Development Report Addendum

Block Plan Area 9 in the Township of Smithville

Applications for Block Plan, Draft Plan of Subdivision, and Zoning By-law Amendment

November 4, 2025

Figure 3-3: Revised Lockbridge Block Plan submitted in November of 2025

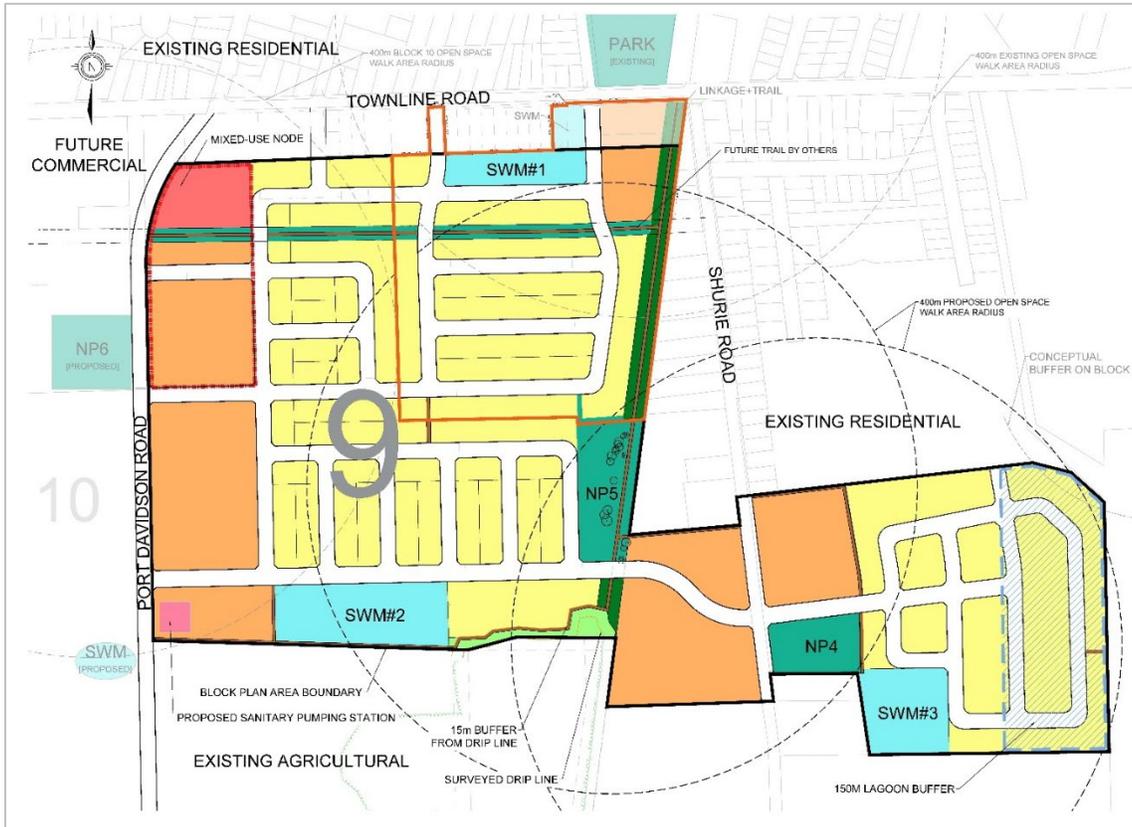
The revised Lockbridge Block Plan proposes the same general land uses as Schedule ‘L’ of OPA 63 and the original Lockbridge Block Plan but provides some minor adjustments and “fine tuning”. The reduction of overall land area for the Block Plan Area from 63.4 ha to 60.89 ha is due to the realignment of Port Davidson Road to meet Canborough Street at Townline Road. Below are key revisions in the revised Lockbridge Plan as it relates to the proposed land uses, orientation, and their location:

- The addition of medium density residential designated blocks on Port Davidson Road and Shurie Road;
- The provision of additional pedestrian connections within the Block Plan;

- The re-orientation of residential blocks along the proposed collector road to reduce driveways onto the right-of-way;
- NPs (i.e. NP4 and NP5) are in the same general locations as the original Block Plan which ensures that there is an existing or proposed park within a 400 m walk radius from the future homes;

- The former rail corridor dedicated as a linear park and landscaped for passive and active and open space purposes;
- A reforestation area is proposed to be adjacent to NP5 and be a component of the overall linkage network;

- Addition of a “park walk” radius for adjacent parks and NP4 and NP5;
- Identification and labelling of the surveyed dripline;
- Addition of key land use designations for areas outside of Block Plan Area 9 which align with existing designations of OPA 63;

- The relocation of the proposed Sanitary Pumping Station east of Port Davidson Road into a block within Block Plan Area 9, now on the west of Port Davidson Road; and,

- The three (3) SWMFs are in the same general locations, however their proposed block sizes have been further refined.

Revisions have been made to create more local subdivision roads, to reorient some of the blocks to address the Official Plan policies for collector roads, and to reduce driveways along the proposed collector road. Additional intersections to Townline Road have also been incorporated.

Figure 6-1: Revised DPS prepared by Arcadis

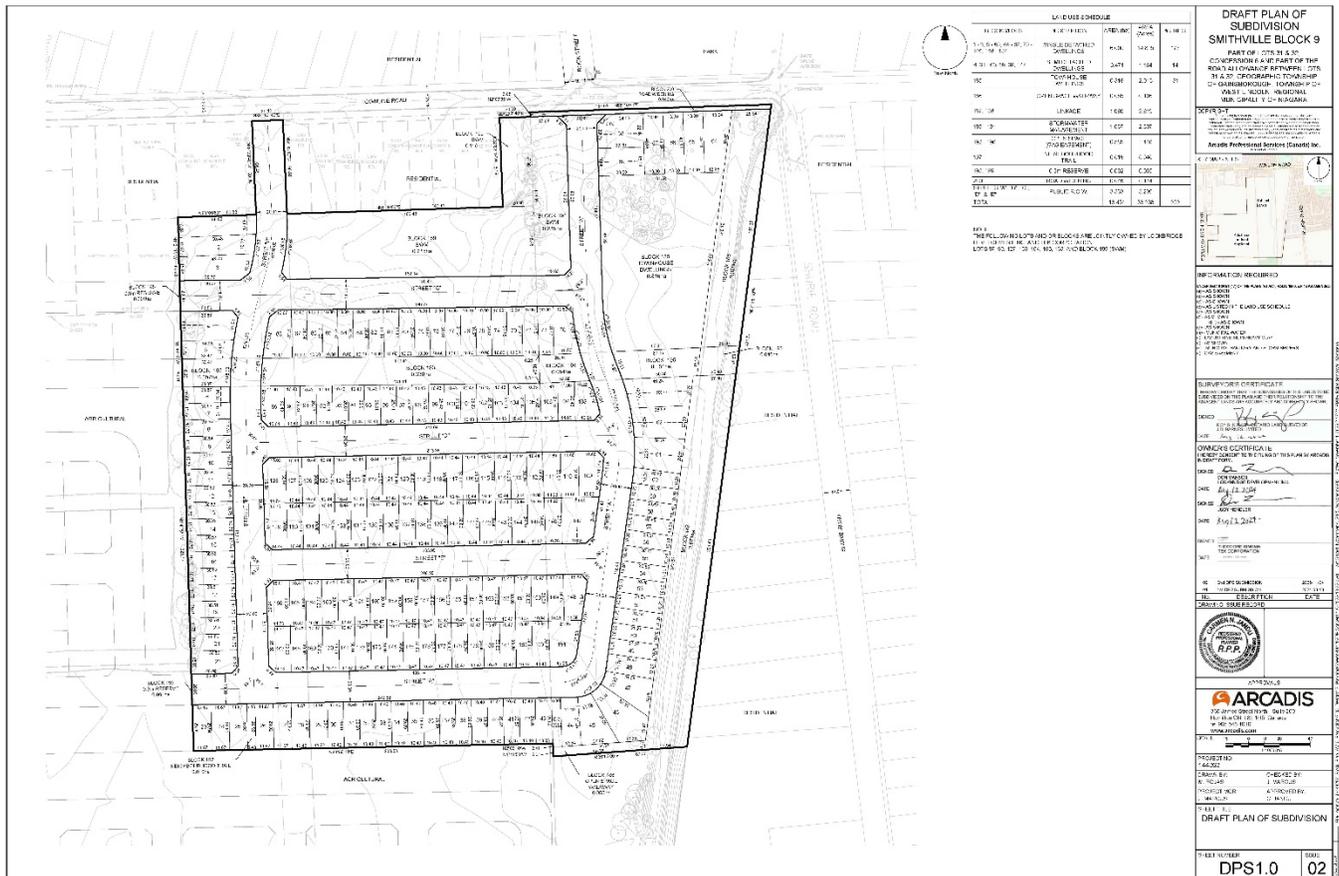
ORIGINAL Draft Plan of Subdivision Submitted August 2024	REVISED Draft Plan of Subdivision Submitted June 2025	Justification
196 residential units	222 residential units	To provide additional residential units within the Draft Plan area

ORIGINAL Draft Plan of Subdivision Submitted August 2024	REVISED Draft Plan of Subdivision Submitted June 2025	Justification
Six (6) new roads	Five (5) new roads	Street 'F' has been renamed as Street 'A'
Street 'B' as a Collectors Road	Street 'B' as a Local Road	To promote connectivity and efficiency of the street network
